# DEVELOPMENT REVIEW BOARD REPORT

MEETING DATE: December 15, 2005

CASE NUMBER/ PROJECT NAME	<b>85-DR-2005</b> <b>Pacific Realty Advisors</b>		
LOCATION	4238 N. Craftsman Court		
REQUEST	Request approval of a site plan and elevations to replace an existing building with a new building.		
OWNER	Pacific Realty Advisors 602-224-8085	ENGINEER	Morea-Hall Engineering, Inc. 602-258-4428
ARCHITECT/ DESIGNER	Sam J West, Architect 480 994-5728	APPLICANT/ COORDINATOR	Sam J. West, Architect 480-994-5728
BACKGROUND	<b>Zoning.</b> The site is zoned Central Business District, Downtown Overlay (C-2, DO), which allows for mixed-use projects consisting of retail, restaurant, personal services, and office.

PRELIMINARY  
ELEVATIONS

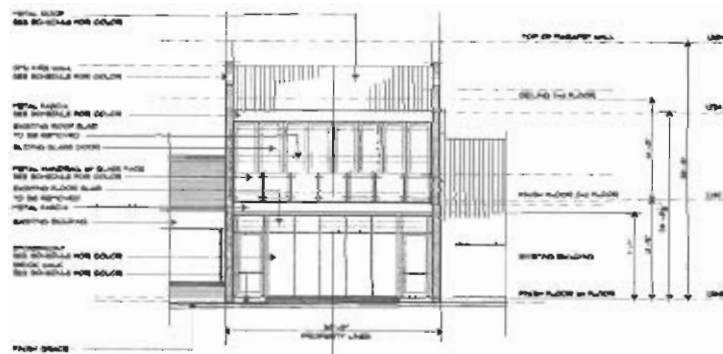
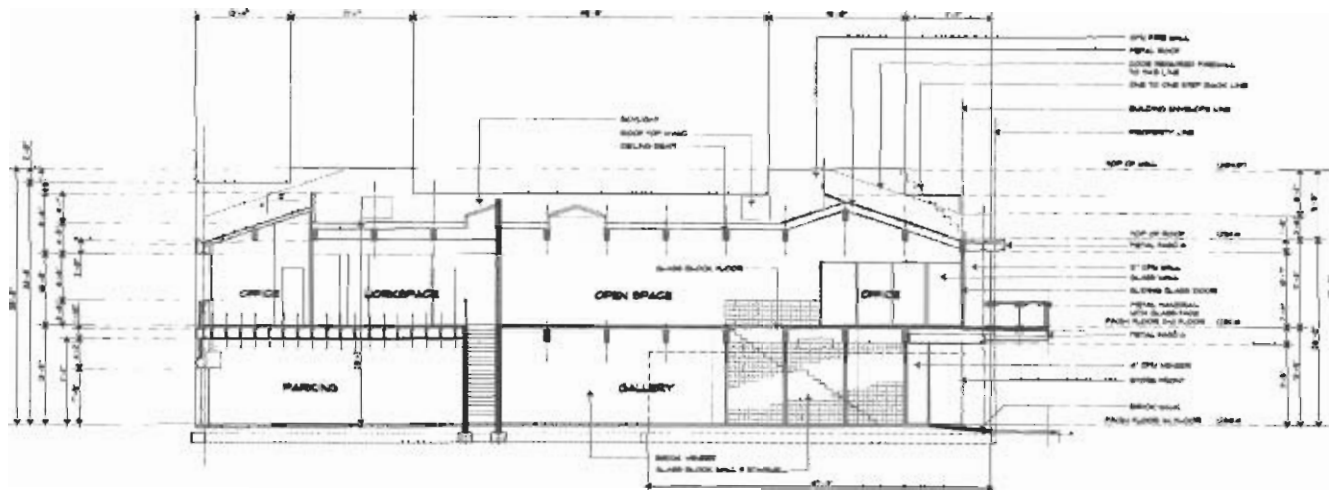
Overall, the building design is in conformance with the Downtown Urban Design and Architectural Guidelines. However, the design guidelines discourage floor to ceiling glass storefronts. The addition of a low wainscot or a pronounced window-sill/ledge to the eastern façade is encouraged.

- c. *The building "step-back" plane shall be consistent with the building cross-sections submitted by SWJ Architecture & Planning with a staff receipt date of 11/17/2005.*

8. Dooley wall fencing shall not be allowed.
9. All site walls shall match the architectural color, materials and finish of the building(s).
10. *Building "wing walls" shall utilize a "stair-step" design at the front and rear of the building to bring it in to compliance with the step-back requirements mandated by the Downtown Overlay, to the satisfaction of Final Plans staff.*
